ADDENDUM 1

To: Prospective Bidders
From: Collier Engineering Co, Inc.
Subject: RFB #1396 Bethesda Elementary School Drainage Improvements, Phase 2

Date: February 19, 2026

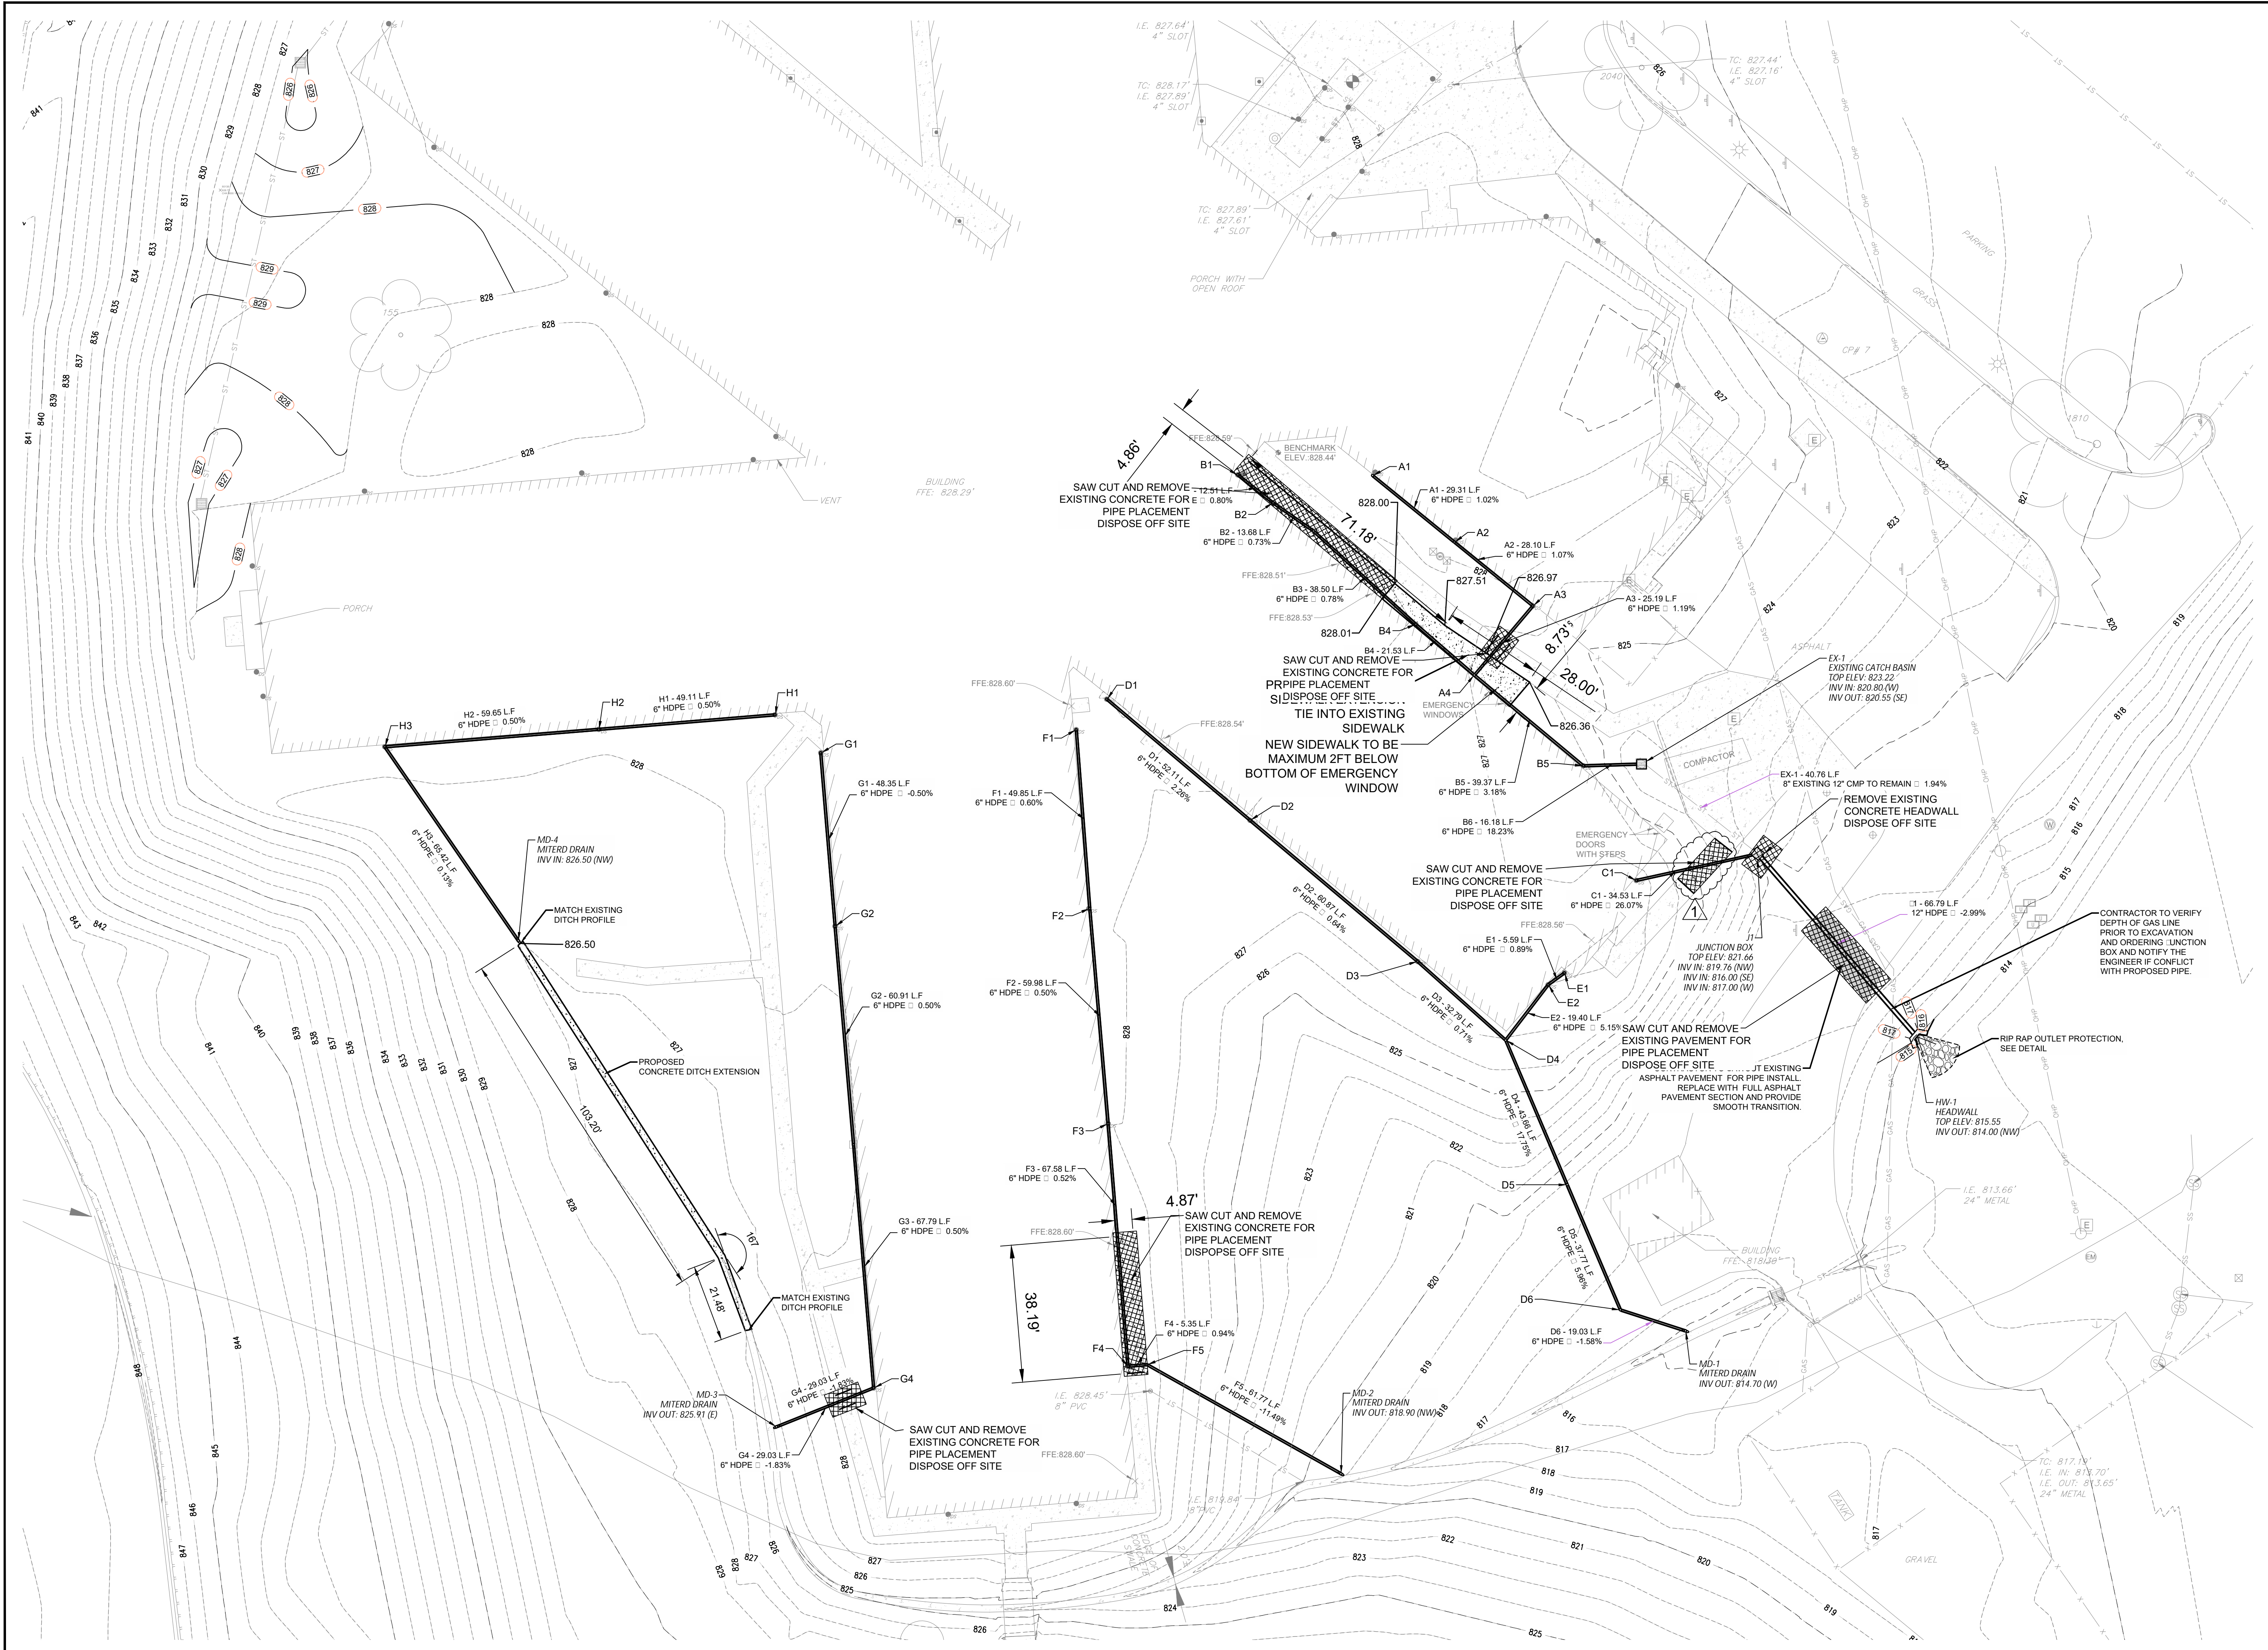
8. It appears the only grading will be on the top left of the site with the elevations circled in red, is that correct?

A: This is correct.

DEMOLITION PLAN
 SHEET NO. C1.10

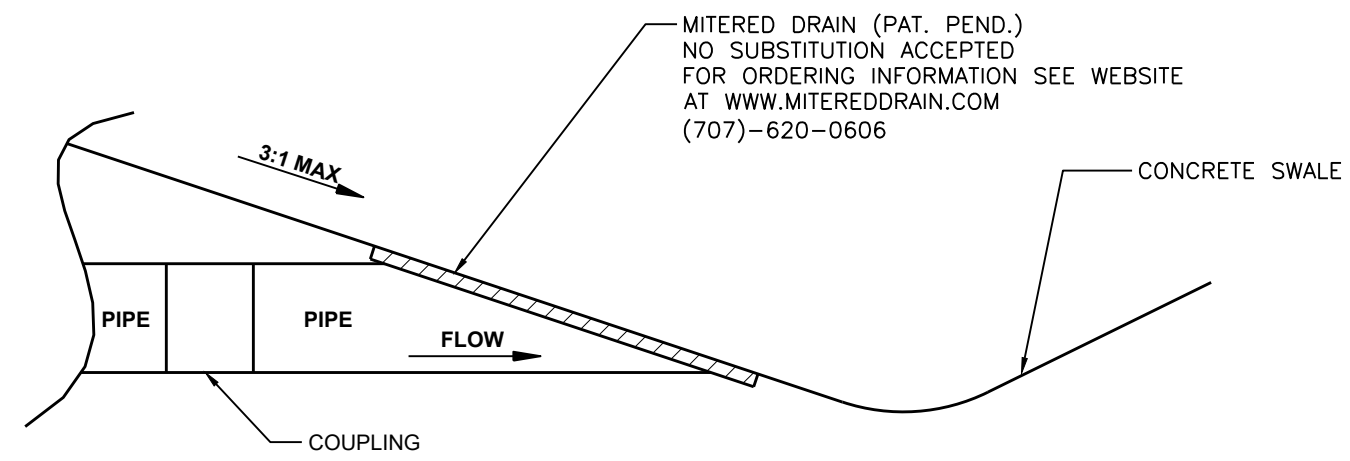
1. Sheet C1.10 Demolition Plan: Remove the original C1.10 sheet and replace with attached revised C1.10 sheet.
 - a. Sheet C1.10 has been revised to reflect necessary demo of sidewalk at southeast wing of the school.

NO.	DATE	BY	DESCRIPTION
1	2/11/2026	MLH	REVISED DEMO AREA ON SIDEWALK

8 PIPE BEDDING
C4.00 NTS

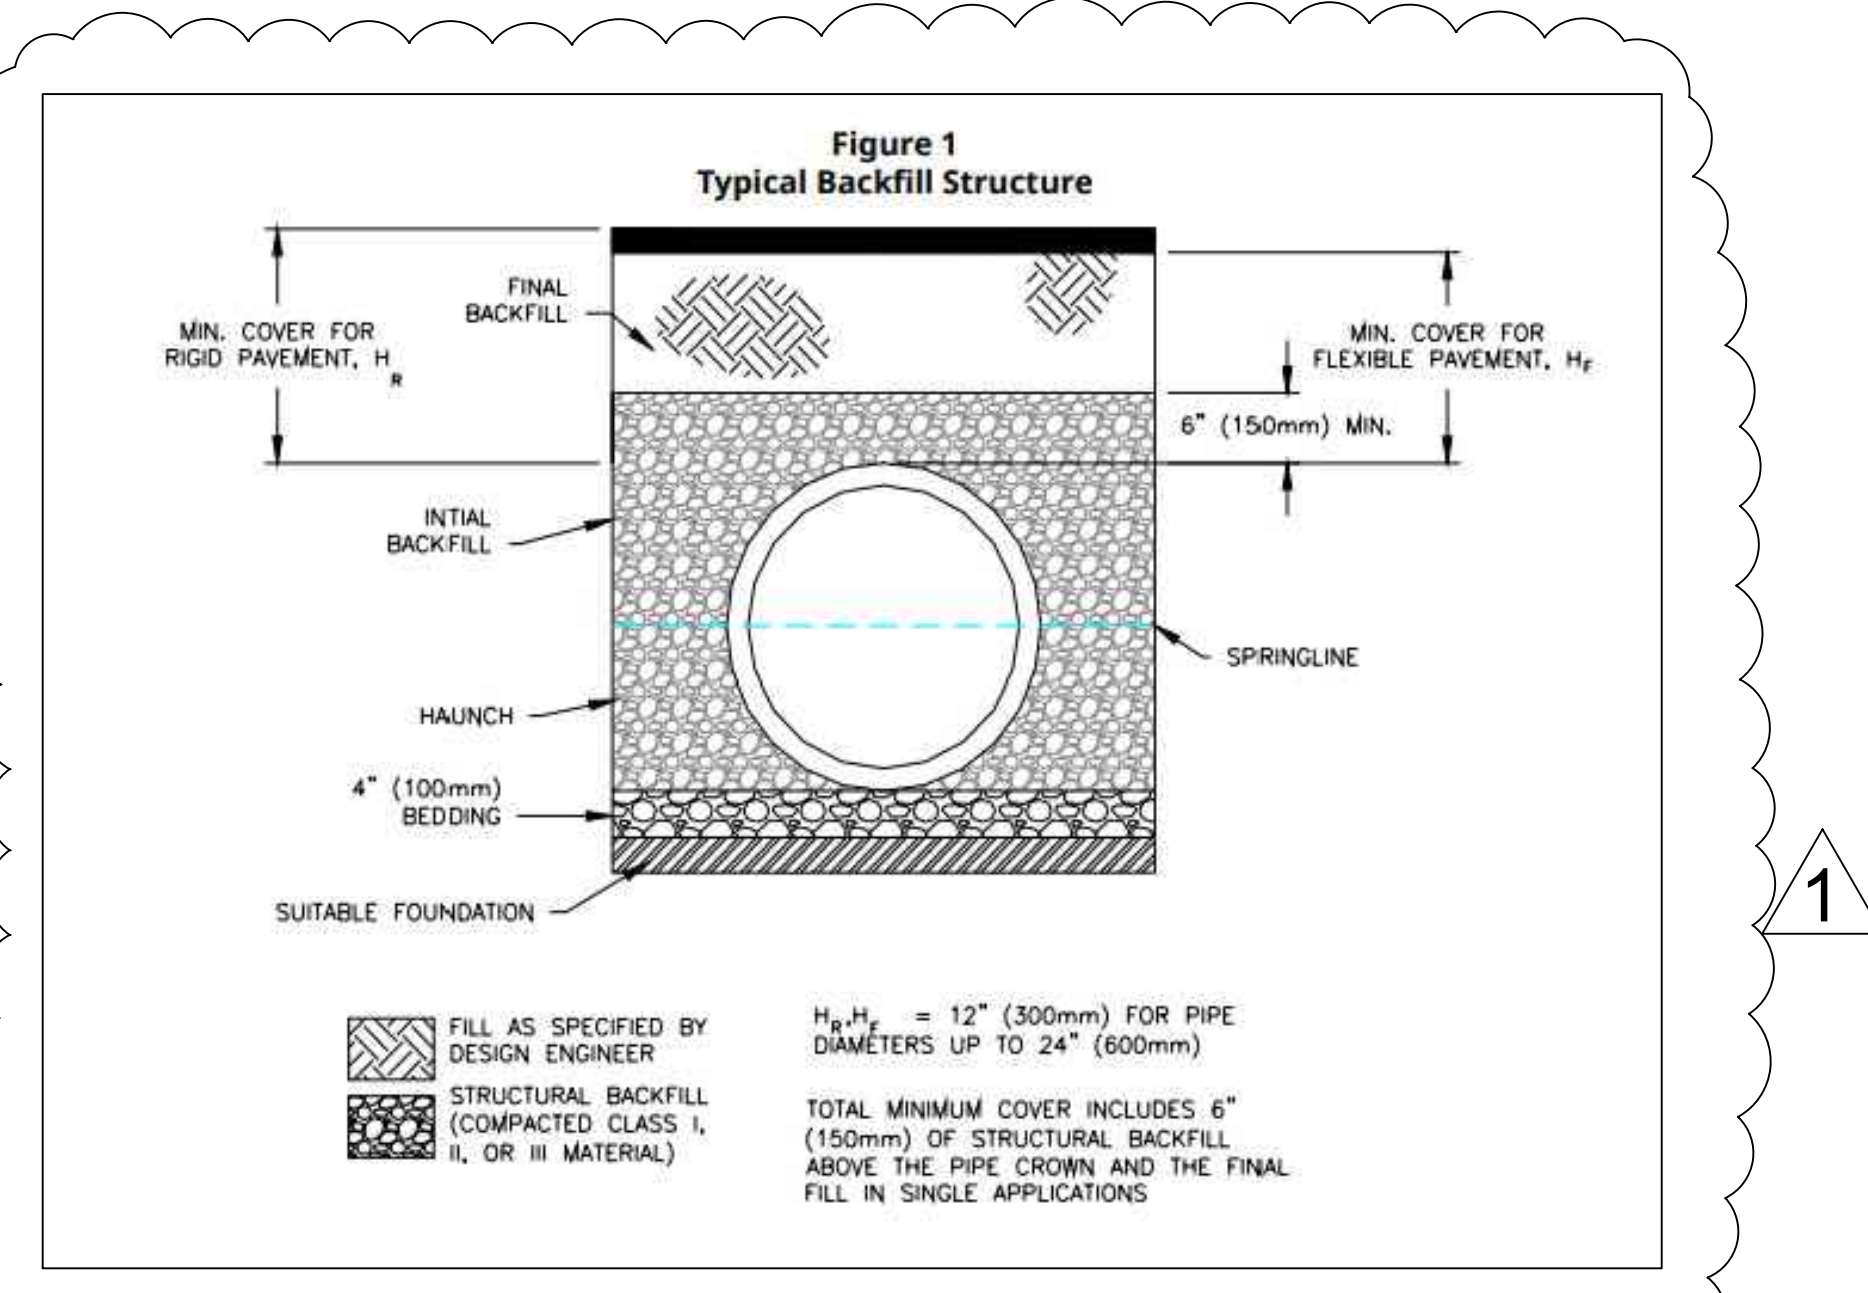
3. Sheet C4.00 Details: Remove the original C4.00 sheet and replace with attached revised C4.00 sheet.
 - a. Sheet C4.00 has been revised to reflect necessary detail for the 6" HDPE pipe backfill

6. What are the backfill requirements for the 6" HDPE line?

A: Attached is the Single Wall HDPE Pipe Installation Guide. See spec for backfill requirements.
